**AMENDMENTS TO THE DRAWINGS**

**REMARKS**

FIG. 2B

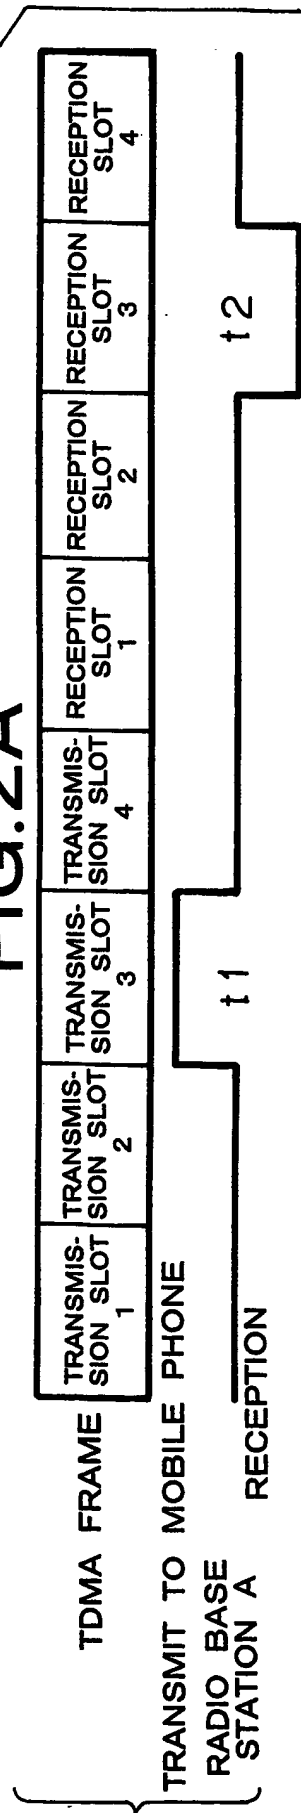
In FIG. 2B, the label “RADIO BASE STATIONS B TO D” has been replaced with the label “RADIO BASE STATION C”.
